Powerco's Customised Price Path Application

Final verification report for Powerco

7 June 2017

Farrier Swier
Consulting

Figure 4 – Overall findings

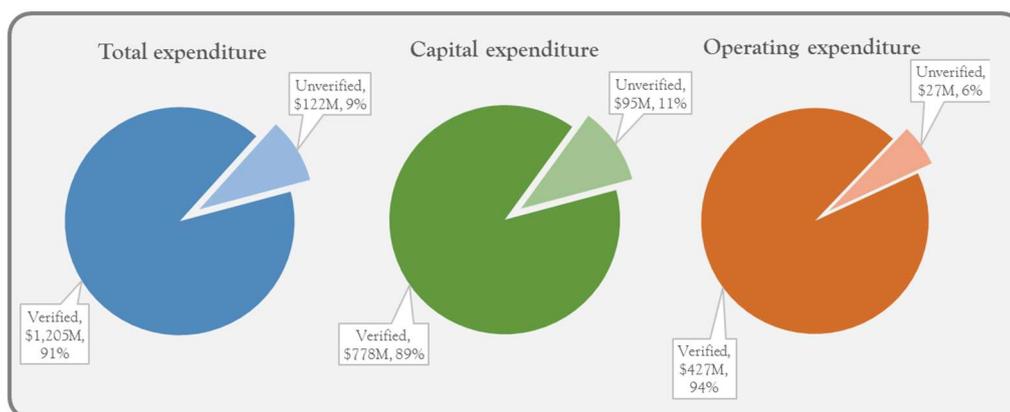
Figure 4 shows that the review team has been able to verify most of the forecast expenditures proposed by Powerco in its CPP. The figure shows the amounts that we were unable to verify against the expenditure objective, and which we recommend that the Commission focus its review on – we refer to these as ‘unverified’. With further information and analysis, the Commission may satisfy itself that some or all of these amounts meet that objective. We have suggested additional information or lines of inquiry that may assist the Commission (see section 1.7.9).

In aggregate, these issues are likely to result in an overstatement of expenditure of up to approximately \$95 million (\$2016) over the CPP period, or approximately 11% of Powerco's forecast capex - as shown in Figure 4. This value does not include uncertainty relating to the growth and security (major projects and minor works) programs, so it could be higher.

These issues are likely to result in an overstatement of expenditure, up to approximately \$27.3 million (\$2016) over the CPP period, or approximately 6% of Powerco's forecast opex. This value is shown in Figure 4.

Figure 5 – Powerco planned SAIDI and SAIFI (FY12–FY23) and unplanned normalised SAIDI and SAIFI (FY18–FY28)

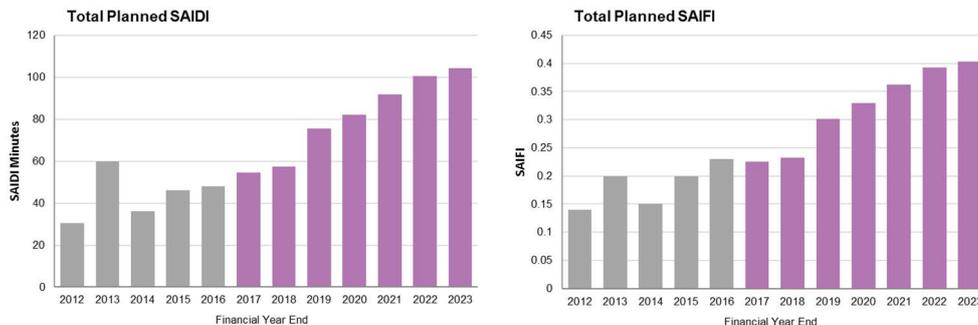
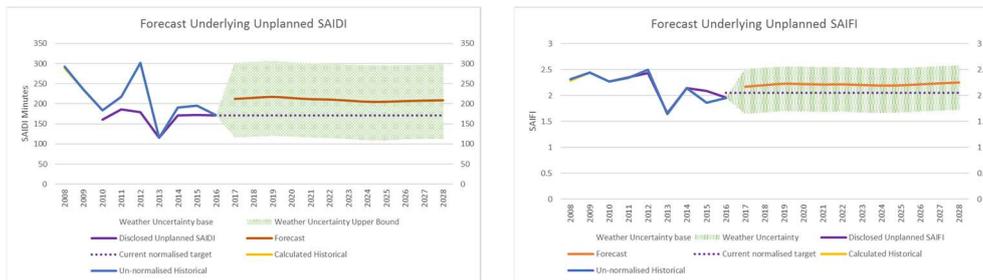
Powerco’s proposed increases in **planned** SAIDI and SAIFI levels are material and reflect the significant increase in asset renewal, maintenance and vegetation management activity proposed for the CPP period (discussed in chapters 3 and 4). Powerco determined the increase by using current estimates of planned SAIDI and SAIFI per activity type and multiplying these by the forecast volume of renewal, maintenance and vegetation management activity, with some adjustment.

Powerco forecasts that normalised **unplanned** SAIDI and SAIFI will remain at current levels over the CPP period. We would, however, expect the significant increase in capex and opex would have a positive impact on normalised unplanned SAIDI and SAIFI.

Figure 6 – Total unplanned SAIDI (minutes, normalised)

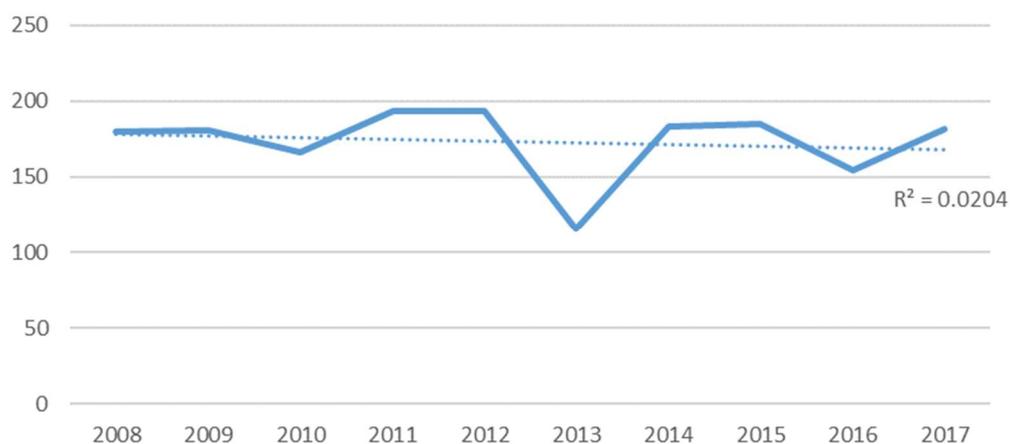
- the normalised reliability data over the longer term 2008 to 2017 does not indicate a sustained deterioration in performance (see Figure 6 and Figure 7 below) – although there is year on year volatility, this is largely explained by potential outliers in 2013 (with relatively good SAIDI and SAIFI performance) and 2017 (with poorer SAIFI performance).

Figure 28 – Extract from Powerco vegetation management forecast model – Volume of tree sites

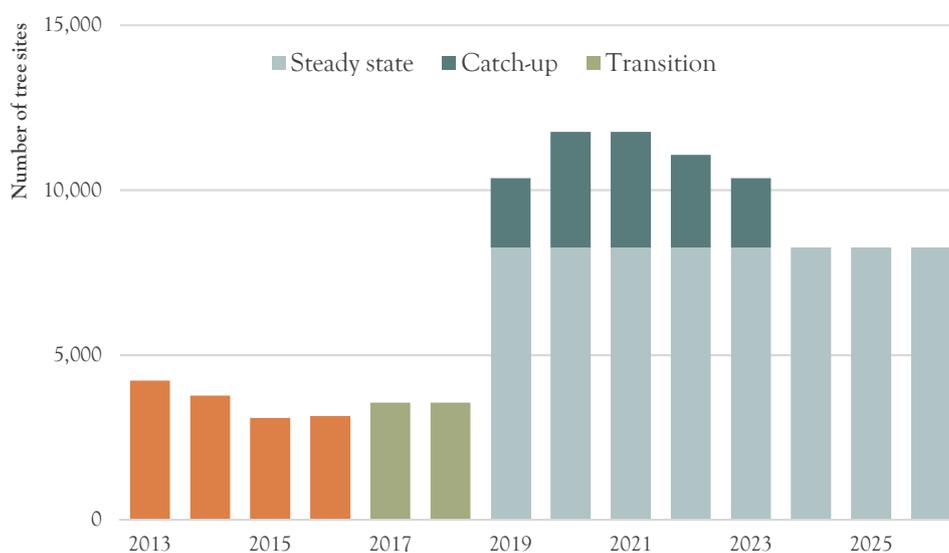
Figure 28 shows the forecast increase in work volumes initially proposed and as reflected in its Vegetation Management Strategy. Following discussion with the review team, Powerco refined its approach to provide a staggered start of cyclic cutting over a three year period 2019 to 2022 with catch up to address the higher volume of trees needing to be cut in the first year's cut in each area only rather than across the five year period. Powerco also included in its modelling the expected volumes of second cuts that would be paid for by tree owners and reduced its forecast expenditure accordingly.

Figure 29 – Vegetation management – Costs per unit line length against customer density (\$2016)

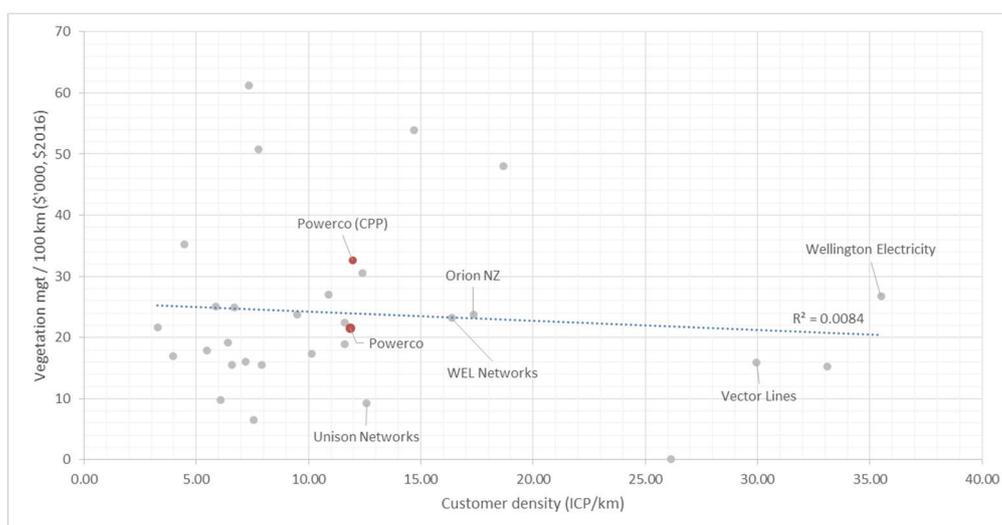
Benchmarking of vegetation management costs (excluding catch up expenditures) against other NZ EDBs is shown in Figure 29. The figure shows that Powerco’s CPP forecast expenditure places it slightly above the average, although the range of EDB’s expenditures is broad.

Additionally, EDB expenditures show little correlation to network size or whether rural or urban. Figure 30 shows the correlation to customer density is also low. This lack of correlation indicates that other factors may be affecting the benchmarking, such as specific vegetation management practices and the extent to which EDBs are compliant with the tree regulations.

Figure 30 – Vegetation management – Costs against vegetation affected length (\$2016)

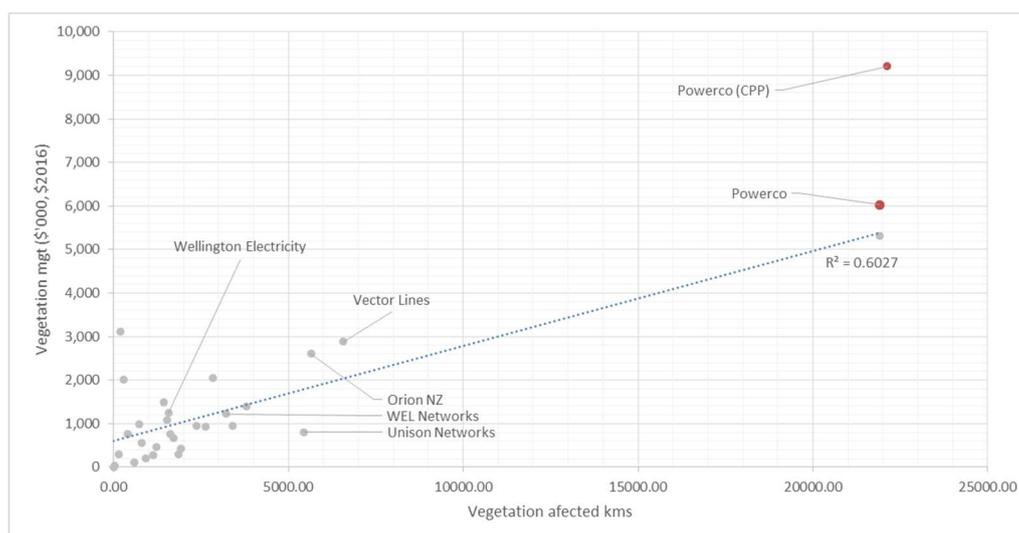
Examining the length of lines affected by vegetation, Powerco reports more than five times the average, with no other EBD having similar lines affected. Although, most EDBs in the dataset are very much smaller than Powerco, and benchmarking is not expected to provide a strong indicator of relative performance, Figure 30 shows that Powerco’s historical expenditure was near the average and that the CPP forecast would be 70% above.

Figure 35 – Historical, trend and forecast unplanned SAIDI (un-normlised)

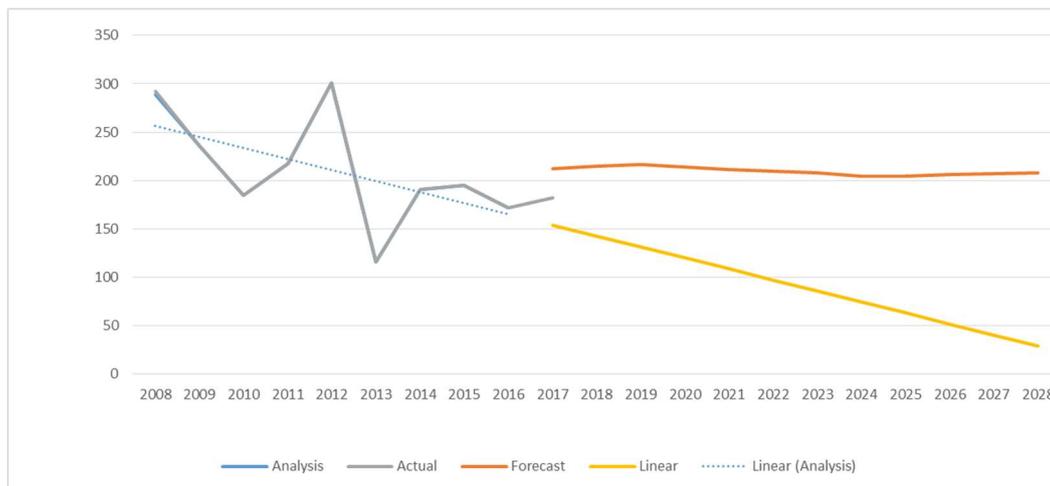
The impact of the approach to modelling and the issues listed above is the forecast unplanned un-normalised SAIDI and unplanned un-normalised SAIFI starts at a higher level than would be expected based on the recent network performance and does not exhibit the long term improving trend that Powerco identified in their model, as shown in the historical data in Figure 35 and Figure 36.

- the model generally accounts for increasing trends in historical data, but does not account for decreasing trends in the historical data. The impact of this is to overstate overall performance as can be seen in Figure 35.
- hard coded values were applied to specific categories to adjust the slope of the historical trend line: 0 (flat) was applied to the fault rates of specific categories; 0.8 was applied for the fault rate for the Unknown category; and 0.2 was applied to the durations. These values were not justified, do not appear to account for the increasing works on the network, and would impact the forecast of the model.
